North Campus Faculty Housing – Phase I  
Project No. FM 100029L/ 986305  
**Addendum No. TWO**

ADDENDUM NUMBER TWO

NOVEMBER 4, 2009

**B-VENT FLASHING  
CONCRETE FLAT TILE**

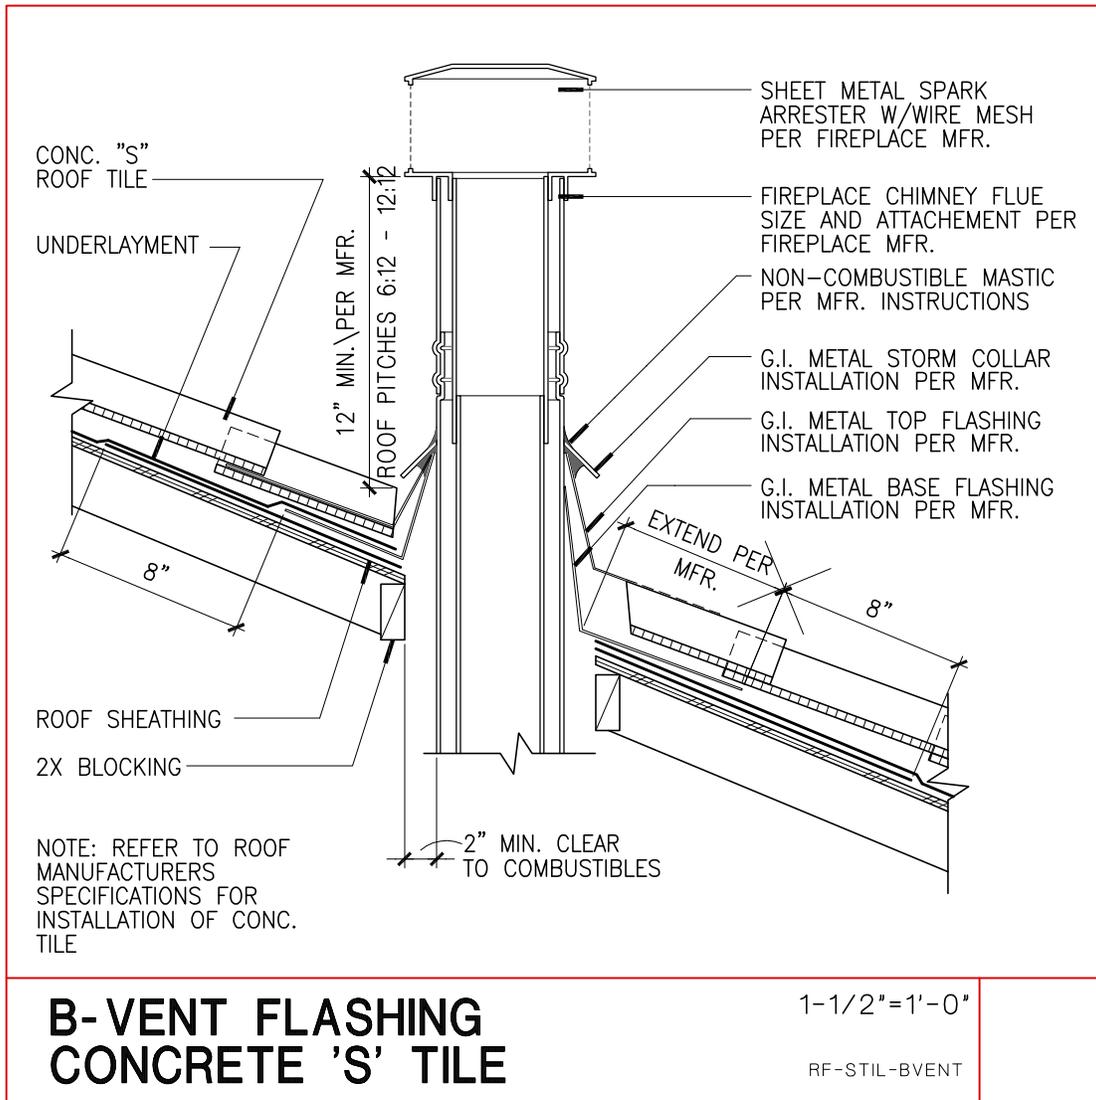
1. 01 B-Vent Flashing at Flat Concrete Tile dated 10-26-09, detail for 'B' vents on Drawing Number Sheets A3.20, A3.70, A4.20, A4.70, and A5.20.

B-VENT FLASHING AT  
CONCRETE 'S' TILE

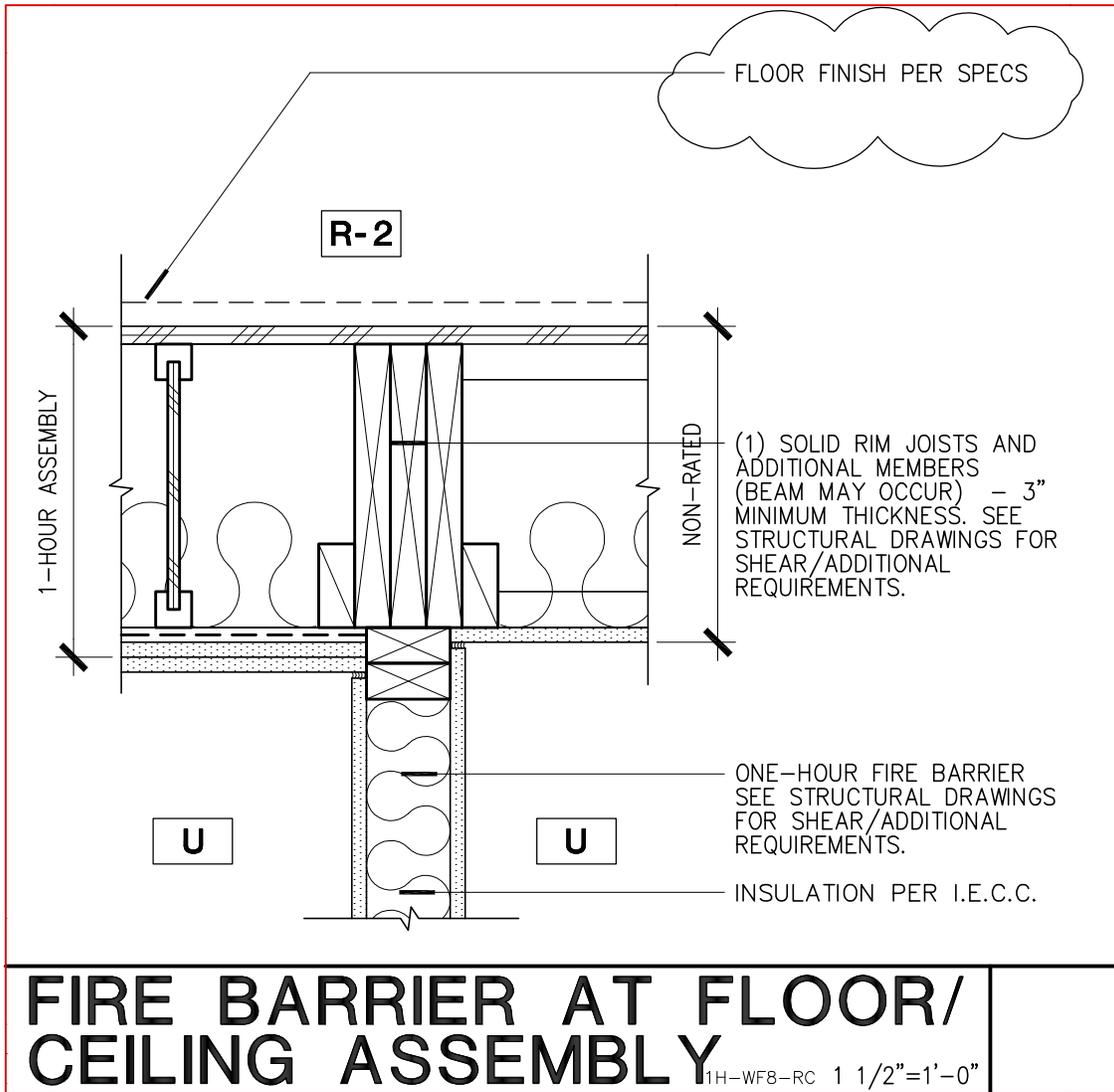
- 2 02 B-Vent Flashing at Concrete 'S' Tile dated 10-26-09, detail for 'B' vents on Drawing Number Sheets A3.20, A3.70, A4.20, A4.70, A5.20

SKETCH  
No. 05

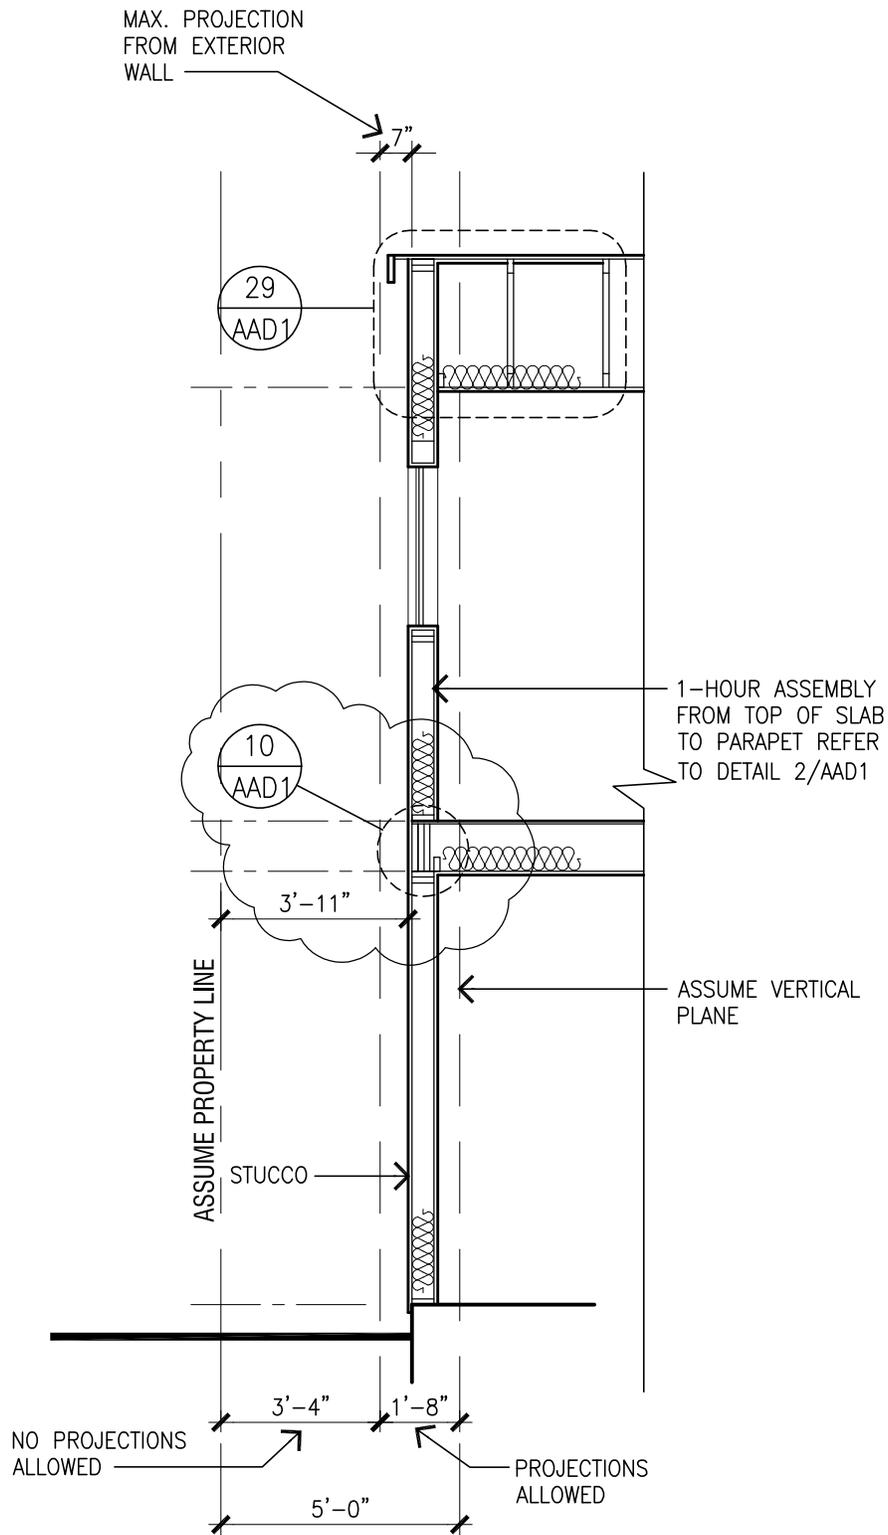
1. Drawing Number A2.10, Buildings 9 and 10 Fire Separation Distance Justification Partial Section – ‘B’ @ Building 9 Only  
**ADD** the following note:  
“1) Refer to Detail 10 on Sheet AAD1 for floor/ceiling assembly on the exterior wall condition. Reference Sketch 03 thru Sketch 06.”

- 5 05 Detail 10/AAD1 Call-Out Location at A2.10 dated 10-26-09

# PARTIAL SECTION - 'C'

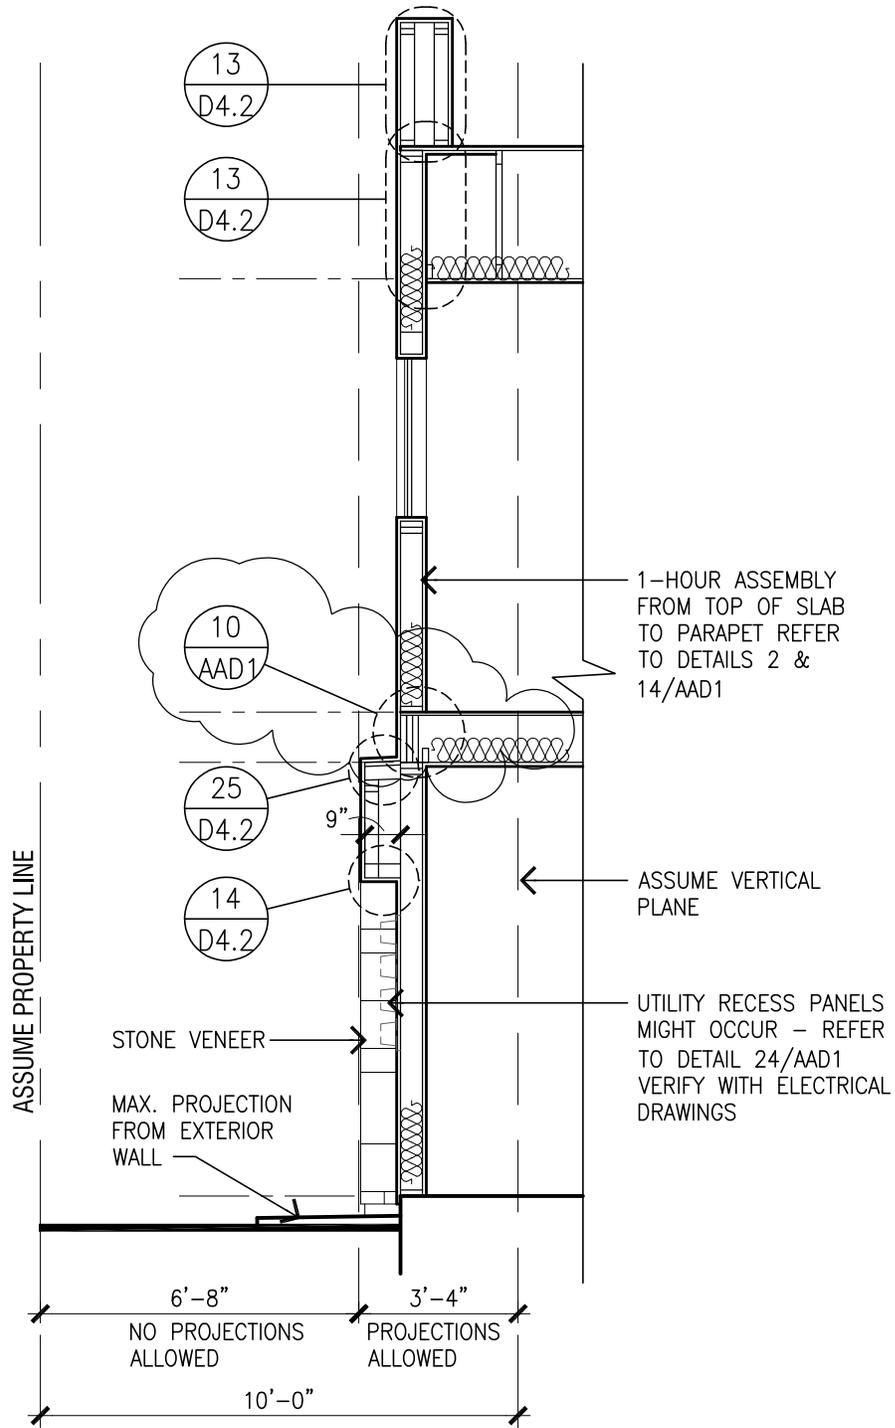
2. Drawing Number A2.11, Buildings 10 and 11 Fire Separation Distance Justification Partial Section – ‘C’ @ Building 11 Only  
**ADD** the following note:  
“1) Refer to Detail 10 on Sheet AAD1 for floor/ceiling assembly on the exterior wall condition. Reference Sketch 03 thru Sketch 06.”

- 6 06 Detail 10/AAD 1 Call-Out Location A2.11 dated 10-26-09

EXT. FOOTING MAT FOUNDATION

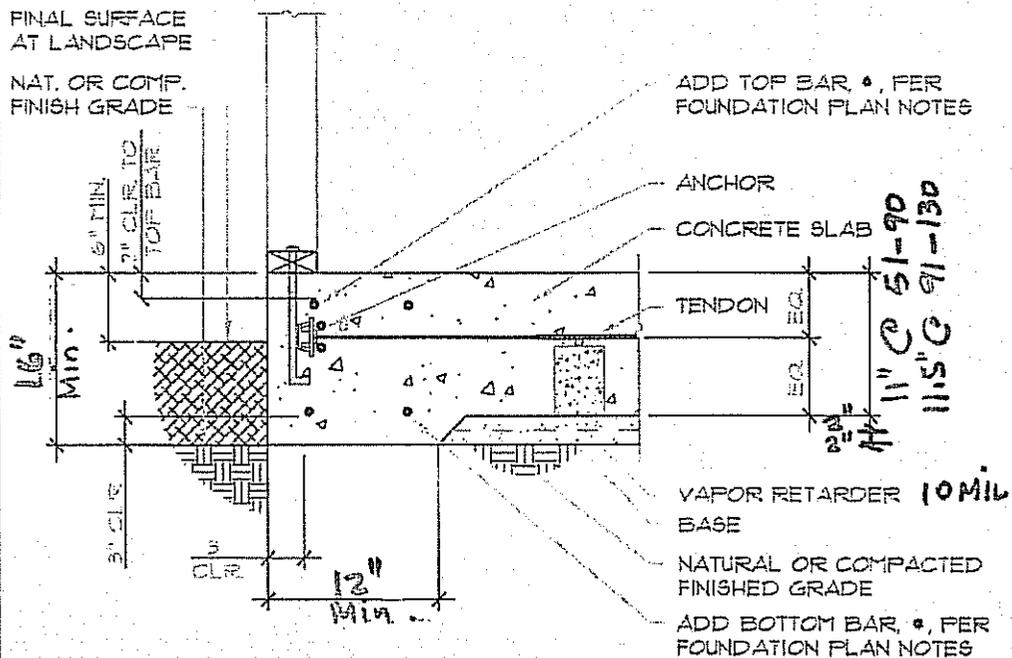
- 7 07 Exterior Footing Mat Foundation dated 10/28/09; replaces Detail 11 on Sheet SD1.0

REPLACE DETAIL 11 ON SHEET SDI.0  
 DATE: 10/28/09 SKETCH NO.07

**TENDON ANCHOR**

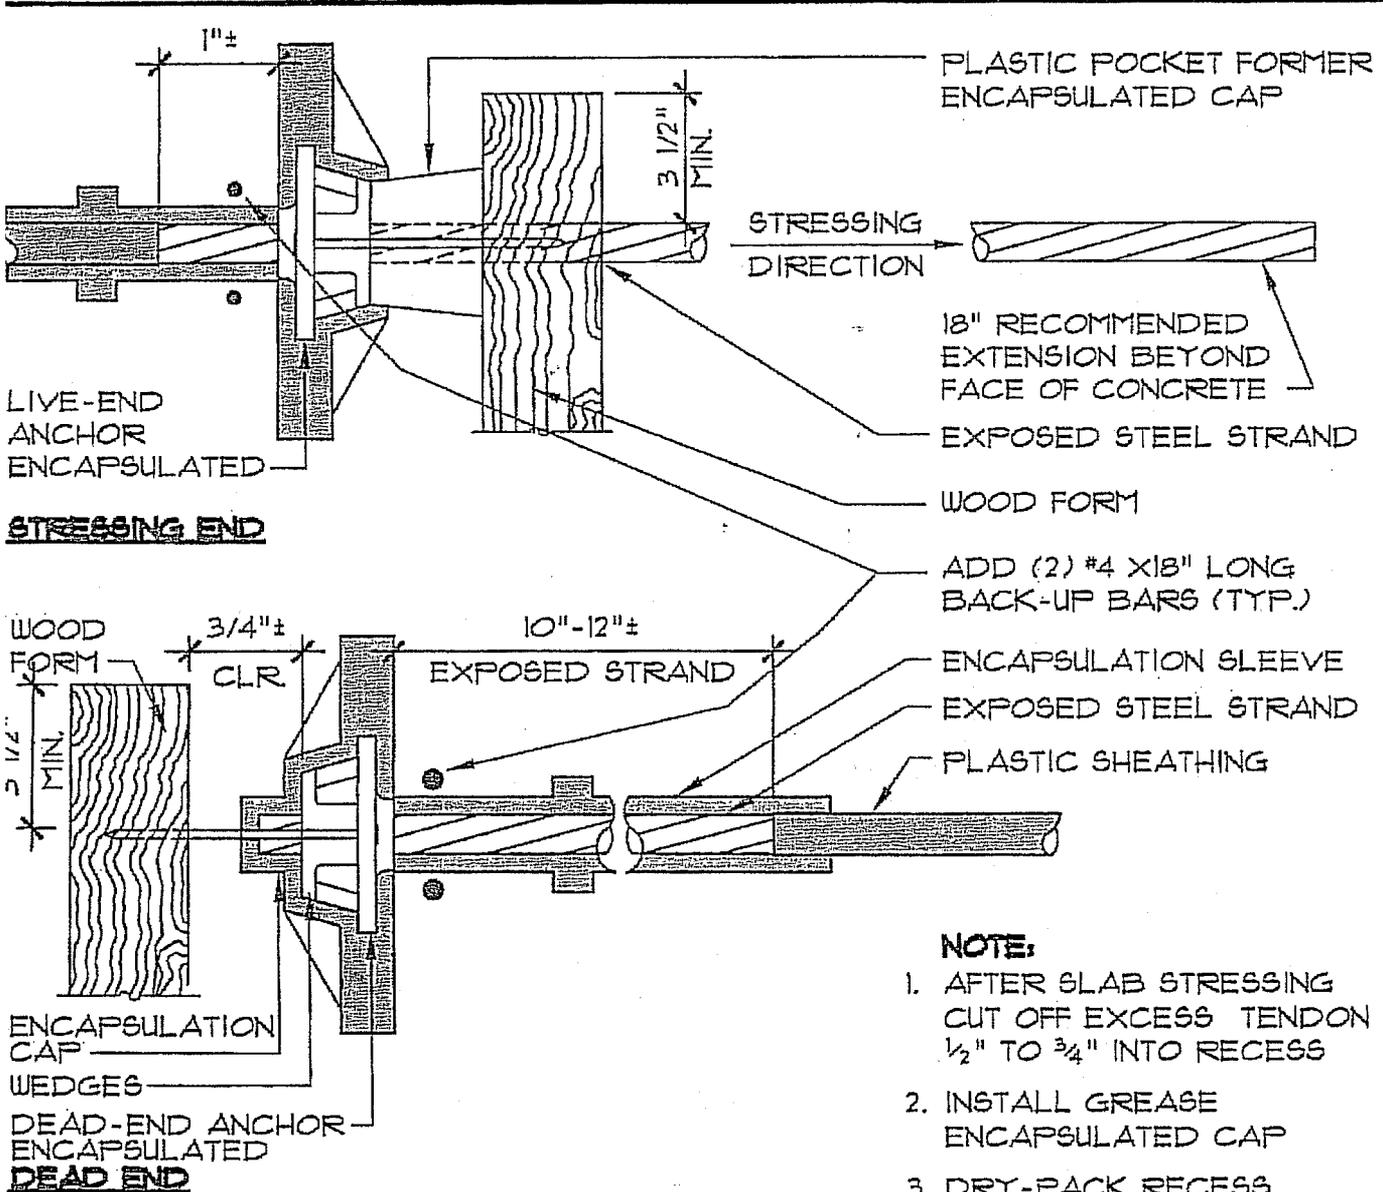
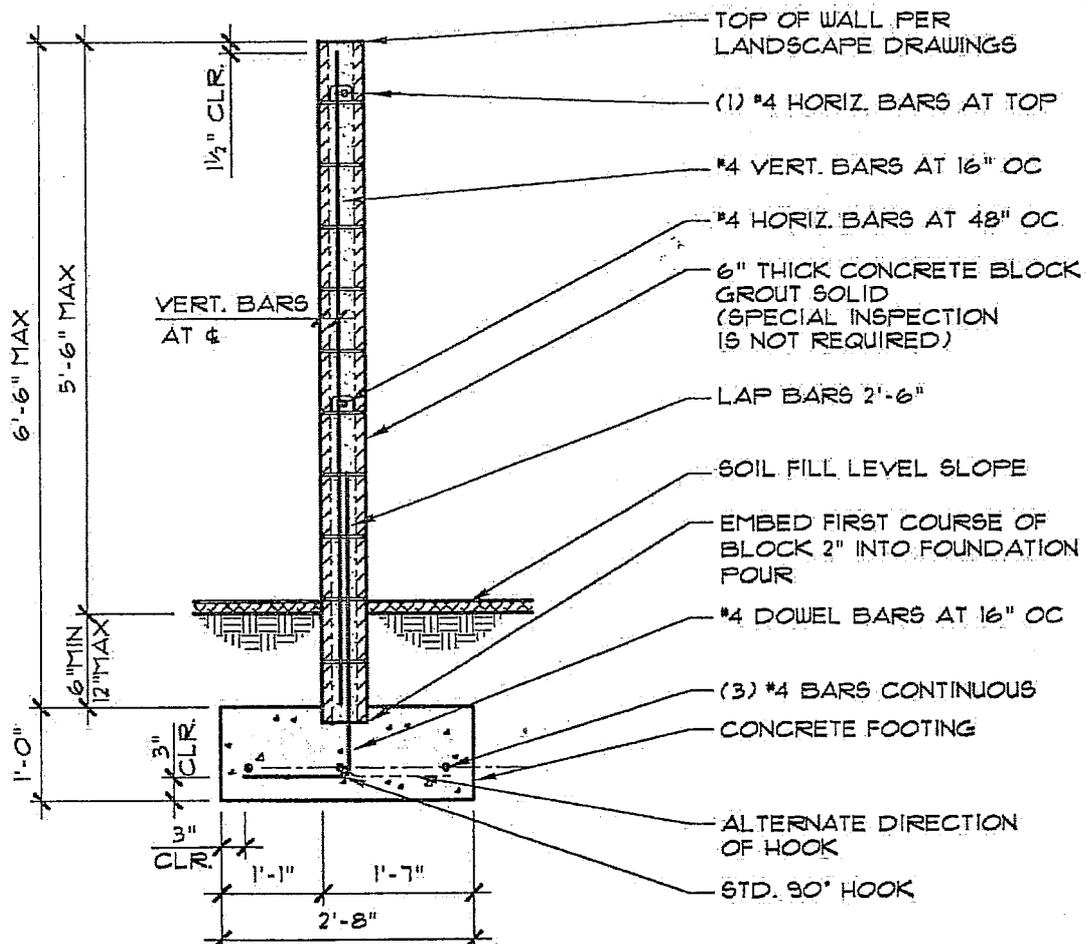
- 8 08 Tendon Anchor dated 10/28/09; replaces detail 4 on Sheet SD1-0

REPLACES DETAIL 4 ON SHEET SD1-0

# MASONRY WALL (6/LCD-2)

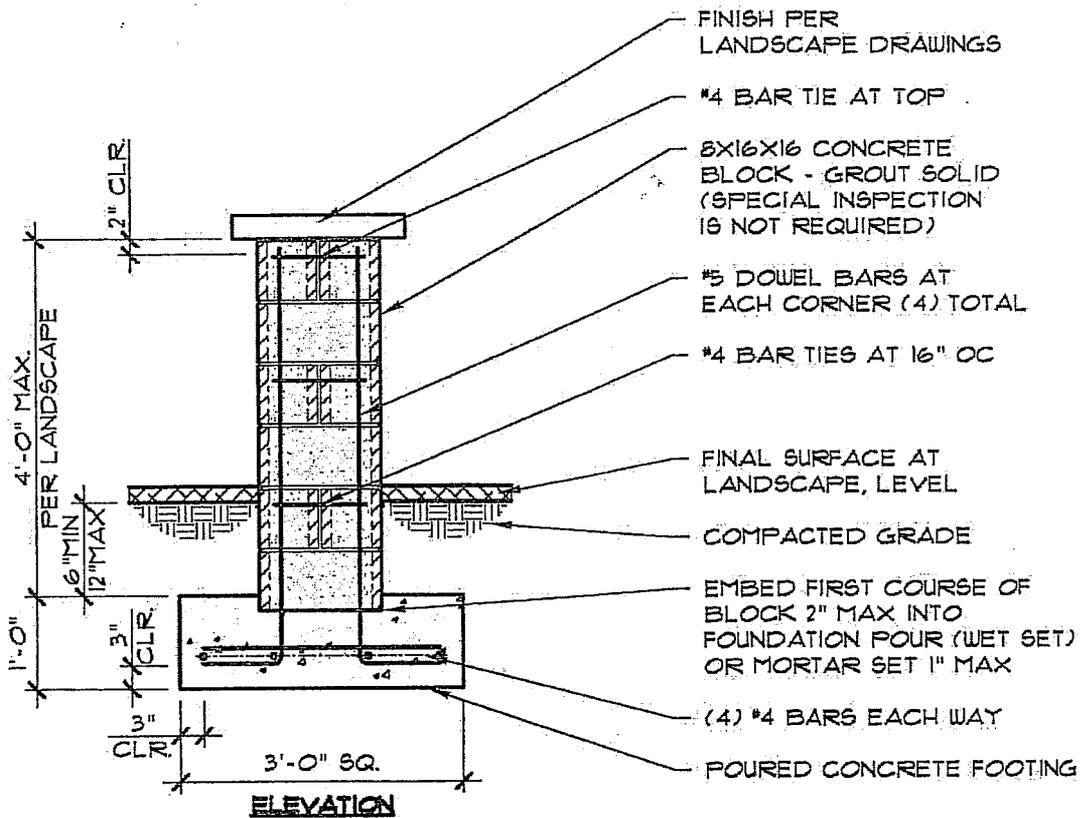
- 9 09 Masonry Wall dated 11/04/09; supplemental structural information for Detail 6 on Sheet LCD-2

SKETCH 9 - SUPPLEMENTAL STRUCTURAL INFO.  
SHEET LCD-2, DETAIL C  
DATED 11/4/09

# 16" PILASTER (2/LCD-2)

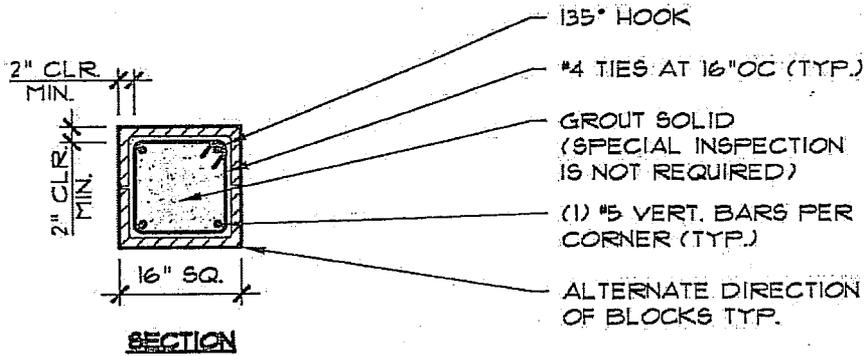
- 10 10 16" Pilaster dated 11/04/09; supplemental structural information for Detail 2 on Sheet LCD-2

SKETCH 10 - SUPPLEMENTAL STRUCTURAL INFO.  
 SHEET LCD-2, DETAIL 2  
 DATED 1/4/09
